RESPONSE TO REQUEST FOR ADDITIONAL INFORMATION

US-APWR Design Certification

RAI NO.: NO. 960-6709 REVISION 0
SRP SECTION: 03.07.02 – Seismic System Analysis
APPLICATION SECTION: 3.7.2
DATE OF RAI ISSUE: 09/24/2012

QUESTION NO. 03.07.02-212:

US-APWR STANDARD PLANT STRUCTURES – PLAN VIEW

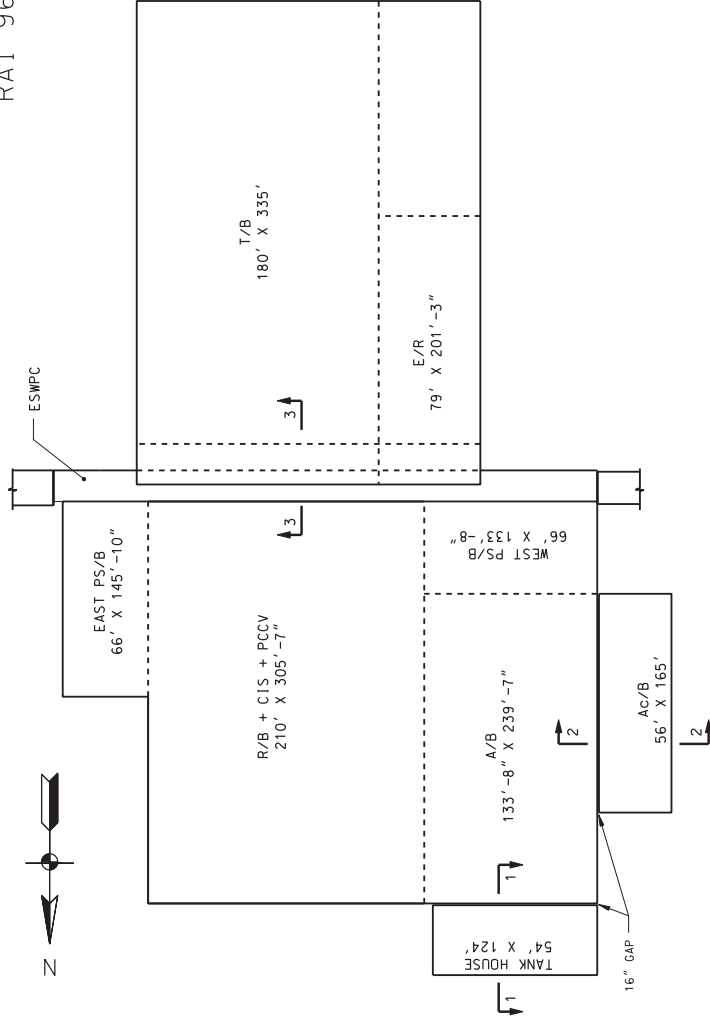
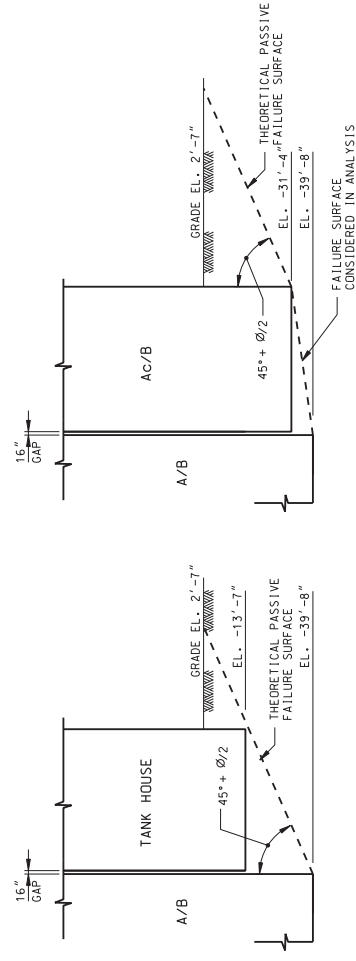
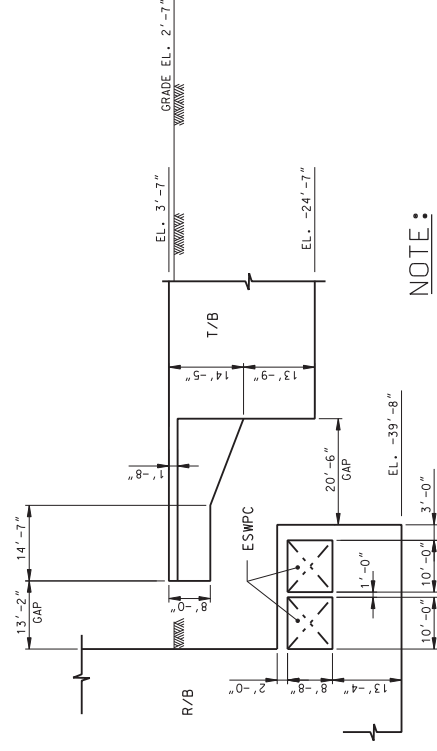
- a) In order to judge the adequacy of the gaps, to document which structures are adjacent to each other, and to document the structures that share a common basemat, the applicant is requested to provide a figure that shows those information. The figure should include all of the Seismic Category I structures and non-Seismic Category I structures at the plant site, the boundary of the separate concrete basemats, and the magnitude of the gaps between adjacent basemats (below grade and above). The structures should include those within the MHI USAPWR design certification and those that are within the COL application scope.

- a) A figure including a plan view and vertical sections for the Standard Plant structures is provided in Attachment 1. The exact locations of the structures within the Combined License (COL) Applicant's scope are site specific. Therefore these structures could not be included in the figure. Adequacy of the gaps between the site specific structures and the Standard Plant structures are to be addressed by the COL

2. The gap between the R/B complex basemat and the turbine building (T/B) complex basemat is much larger (see Attachment 1), so there is no danger of contact between the structures' basemats due to gap closure. A potential issue is the increase in pressure in the backfill in the gap due to the two structures (R/B complex and T/B complex) sliding toward each other. The nonlinear sliding analysis provides a conservative estimate of the relative displacements of the R/B complex and the T/B complex and resulting gap closure (see the answer to Question c, below). This conservative estimate is then used to calculate the increase in pressure on the structural walls adjacent to the gap, due to compression of the backfill in the gap. These pressures are used for the design of structural below grade walls.

The gap between the R/B complex and the T/B is much larger, on the order of 13 feet (see Attachment 1 provided as part of the Answer to part a) of this question), therefore there is no concern regarding structure hammering. The gap closure due to sliding is calculated to estimate the increase in pressure on the structural walls adjacent to the gap, due to compression of the backfill in the gap. This gap closure is addressed as follows: For each of the two structures, nonlinear sliding analyses are performed for six generalized layered subgrade profiles and five acceleration time histories compatible with the certified seismic design response spectra (CSDRS). At each time instant, the total displacement for each structure is calculated as the vector sum of the sliding displacements in the X and Y directions. The nonlinear sliding analyses provide the maximum total displacements for each structure, each subgrade profile and each acceleration time history. The maximum expected sliding is calculated by statistical processing of results from different subgrade profiles and time histories, and represents the maximum value with exceedance probability of 2.5 percent (more details are provided in Section 5.4 of Technical Report MUAP 12002, Rev. 1). The gap closure is calculated as the absolute sum of the maximum expected values for the two structures (R/B complex and T/B complex). This calculation accounts for the possibility of the seismic waves to arrive in any direction, and for the two structures experiencing out of phase motions. Thus, the maximum gap closure due to sliding is $\Delta_{\text{sliding}}=0.75+0.2=0.95$ inches.
